# Technical Service Information

## THM 4L80-E CENTER GEAR BOX CHANGES FOR 1999 MODELS ("REVISED INFORMATION")

Figure 1

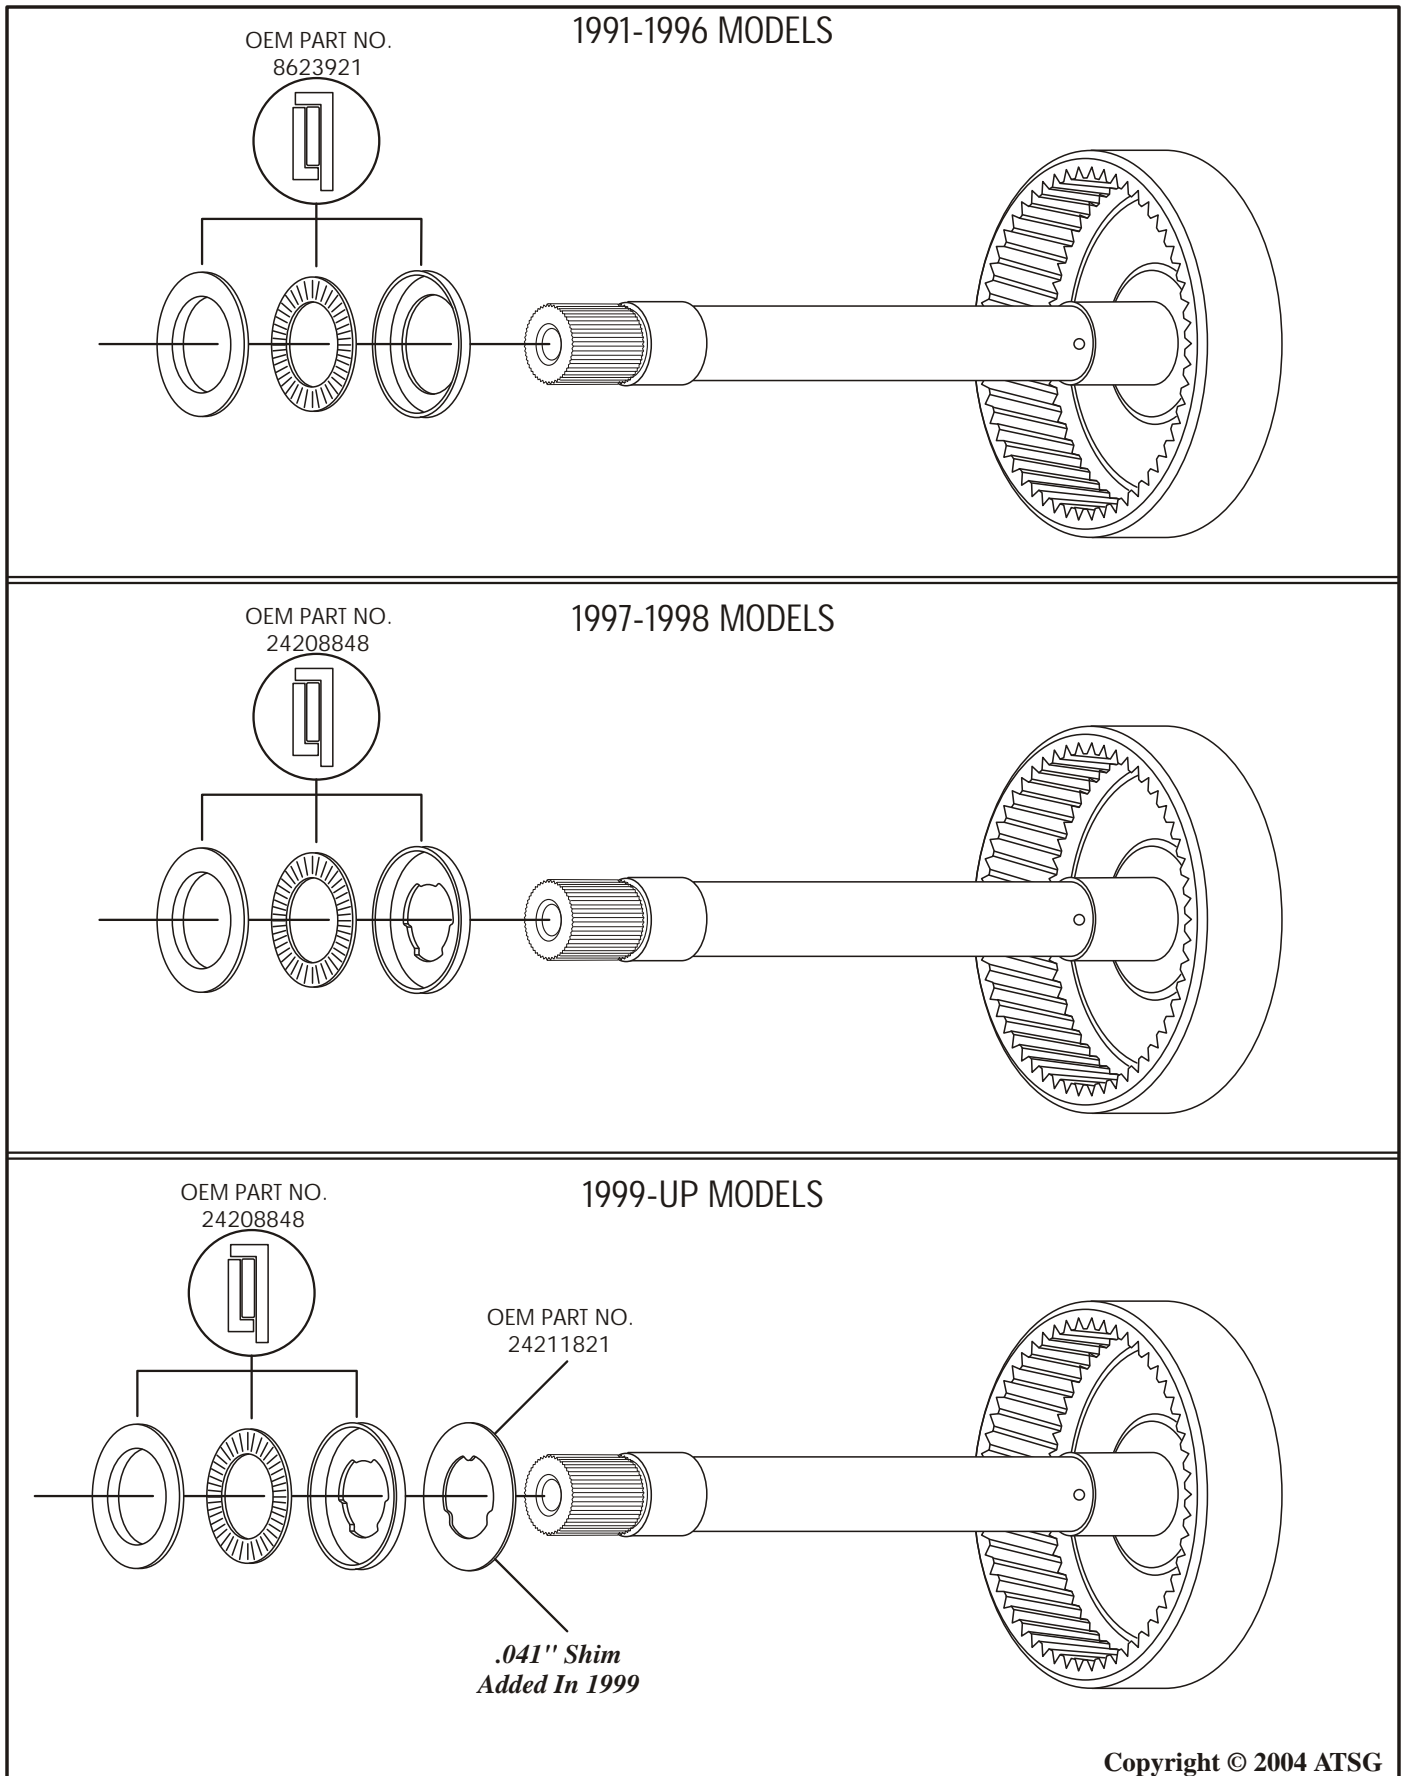
**CHANGE:** Beginning at the start of production for all 1999 model THM 4L80E transmissions, the planetary pinions on both carriers were produced 10% thicker than the previous models, as shown in Figure 1. This engineering change required the addition of a .041" shim in the gear train to re-center the sun gear in the new planetary pinions and affected several internal parts, that may create some confusion, and thus some mis-assembly concerns.

- (1) PLANETARY PINION GEARS - Were increased in length by approximately .075" in both front and rear carriers, as shown in Figure 1, for increased durability.
- (2) ADDED .041" SHIM - There was a .041" shim added between the thrust bearing and the rear internal ring gear, to re-center the sun gear in the revised planetary pinion gears, as shown in Figure 2.
- (3) CENTER SUPPORT - Required a .041" recess to be machined into the center support bearing surface, to accommodate the sun gear being re-centered in the revised planetary pinion gears, as shown in Figure 3.

Figure 3

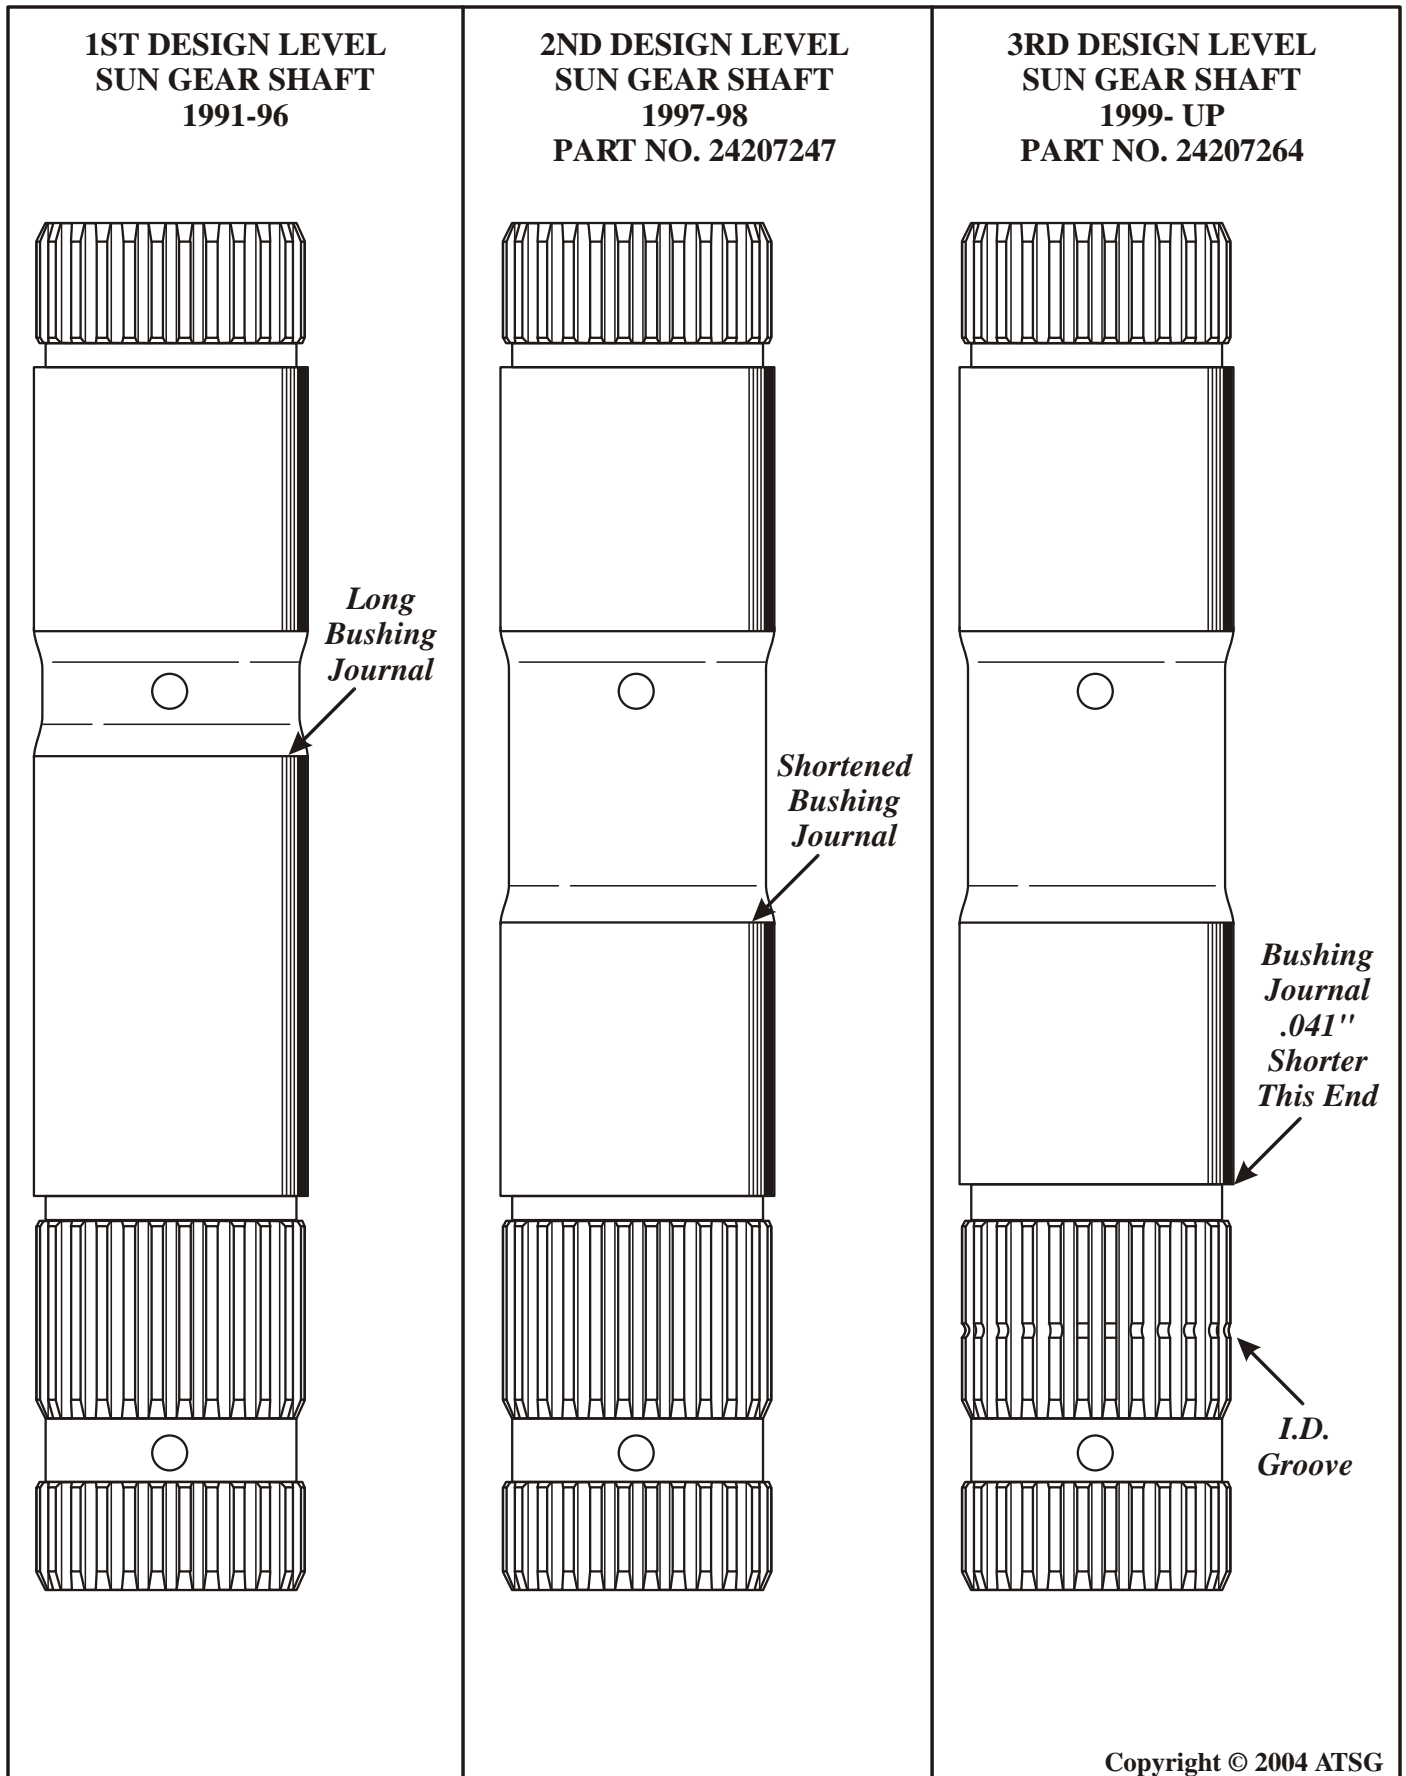
**SPECIAL NOTE:** *Sometime in 2000 GM. eliminated the only visual identification from the updated center support and it now "Requires" measurement for identification, as shown Figure 3.*

Figure 4

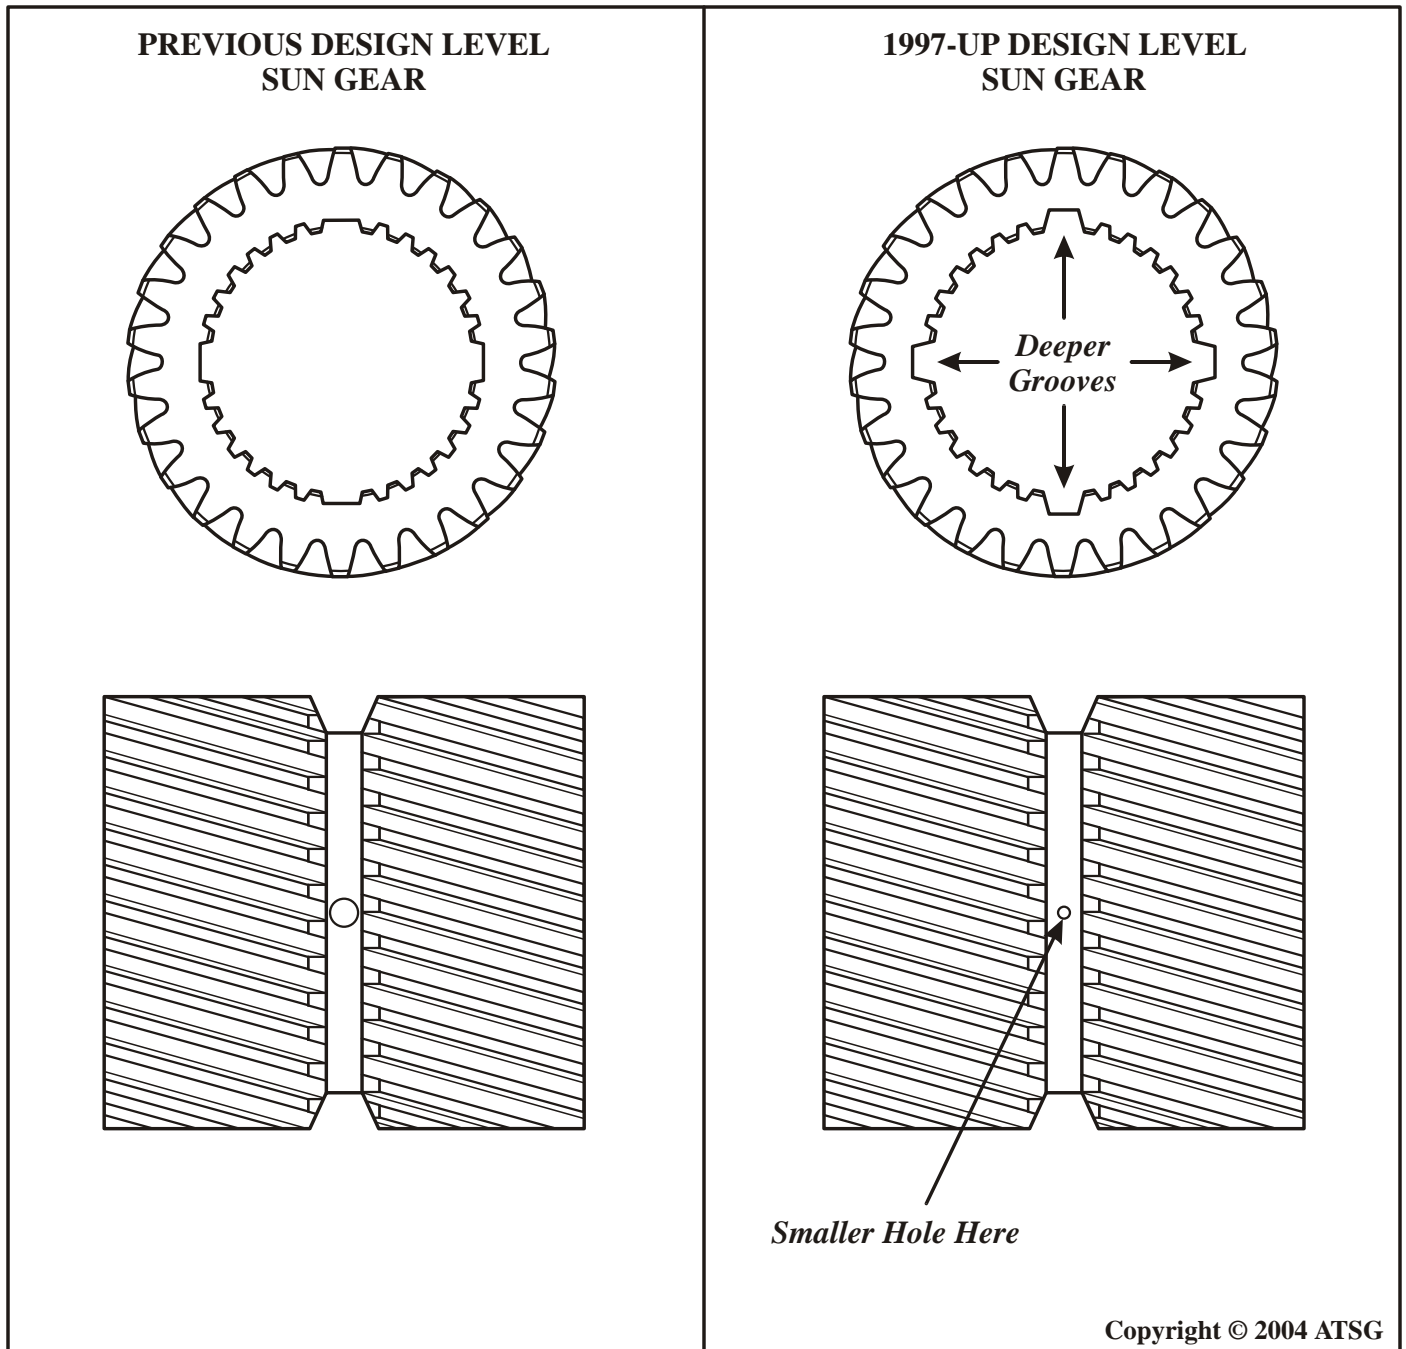
- (4) SUN GEAR SHAFT - Required that .041" be removed from the bottom of the rear bushing journal, to accommodate the re-centering of the sun gear in the revised planetary pinion gears, as shown in Figure 4. Notice that revised sun gear shaft can be identified with a groove cut into the shaft splines, as shown in Figure 4.

Figure 8

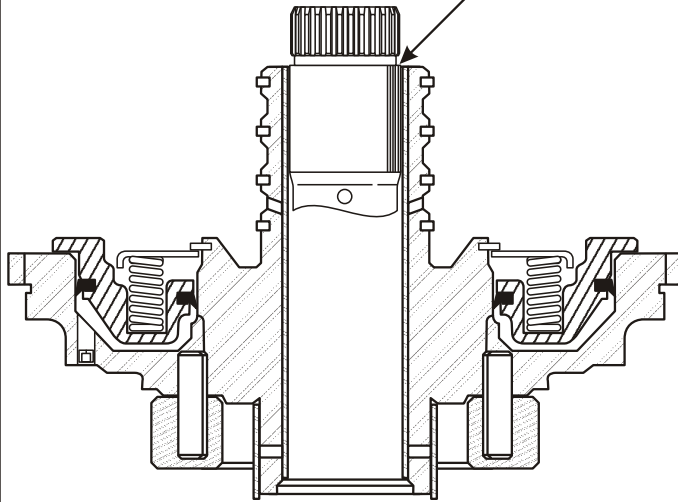
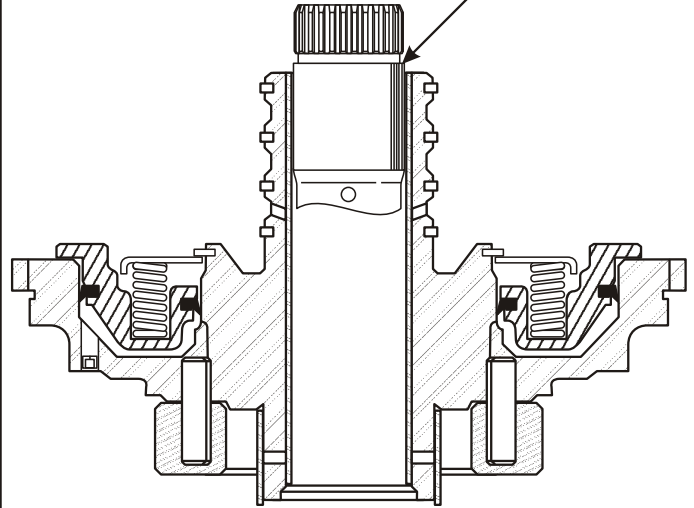
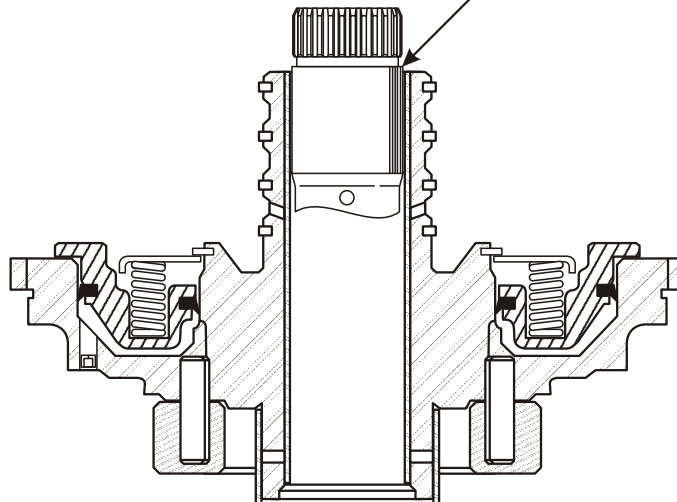
**SPECIAL NOTE:** *Some mis-assembly examples are illustrated in Figure 8 with some dimensional checks to prevent this from happening to you.*

1999 SUN GEAR SHAFT  
WITH 1997-98 CENTER SUPPORT  
AND NO .041" SHIM

*Shaft Journal  
Approximately  
Flush With Support*

1997-98 SUN GEAR SHAFT  
WITH 1999 CENTER SUPPORT  
AND WITH .041" SHIM

*Shaft Journal  
Approximately  
.090" Above Support*

"CORRECT ASSEMBLY"  
WITH PROPER  
SUN GEAR SHAFT  
AND CENTER SUPPORT

*Shaft Journal  
Approximately  
.050" Above Support*
